**Temporary Public Vehicle Park (Excluding Container Vehicle) for a Period of 5 Years
in "Village Type Development" Zone,
Various Lots in D.D. 117, Shiu Tsiu San Tsuen, Tai Tong, Yuen Long, New Territories**

(S.16 Planning Application No. A/YL-TT/784)

Stormwater Drainage Proposal Report

Responses to Comments from Government Departments on Planning Application No. A/YL-TT/611

SECTIONS A-A AND B-B

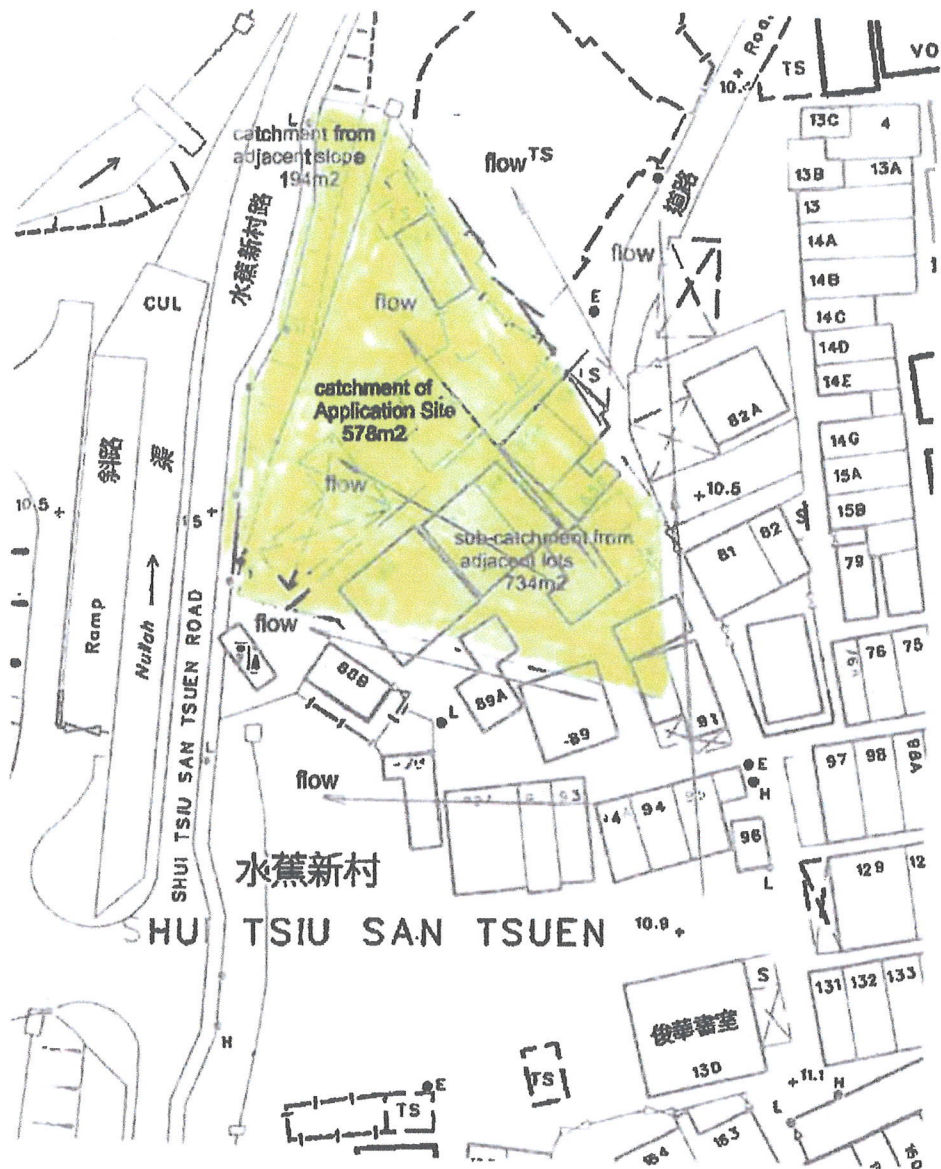
DSD for more details in preparing the drainage proposal. Please review the drainage facilities size accordingly.	
v)	Catchpit should be provided at the turning point of the proposed u-channel, please review.	v) Noted and a catchpit C4 is added
vi)	Please advise if any site formation/levelling works to be carried out under this application.	vi) The application site is presently well formed and covered with concrete paving. No site formation/levelling works will be carried out under this application.
vii)	According to R-to-C, it is noted that no wall or hoarding to be erected or laid along the site boundary under this planning application. If affirmative, please clearly indicate on the drainage plan for record.	vii) Noted. A note stating that no wall or hoarding is to be erected or laid along the site boundary is added in the drainage plan.
viii)	The proposed drainage facilities should be clearly shown on the cross sections (Section A-A and B-B) for clarity.	viii) Noted.

**PHOTO NO. 7
(Internal Condition of Existing 700mm U-Channel)**

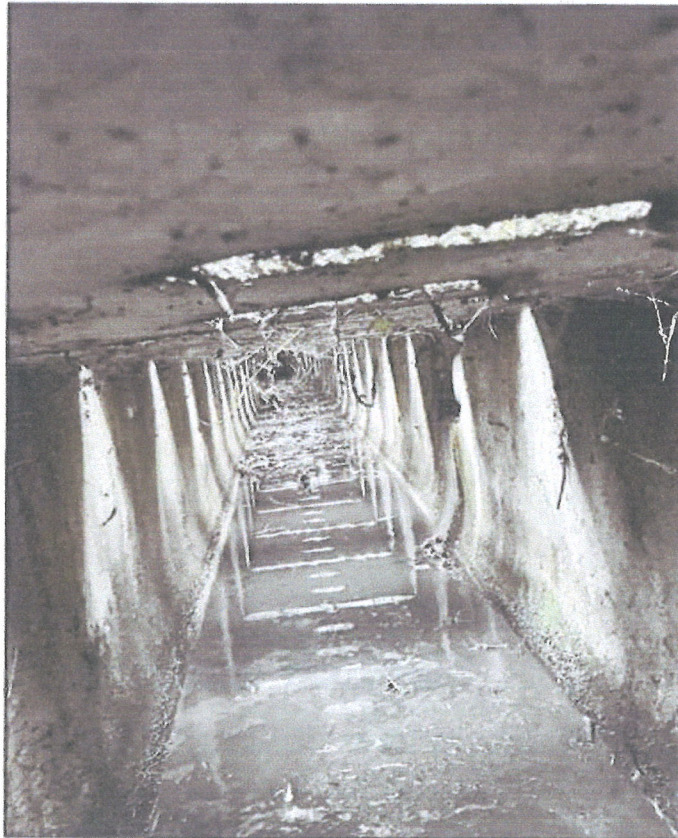
ix)	Please take more photos showing the internal condition of the existing 700mm surface channel for review. Please also take more photos at different locations and views for this channel for reference.	ix) Noted. Photo Nos. 6 and 7 showing the existing 700mm u-channel and the internal condition of the channel are added for reference.
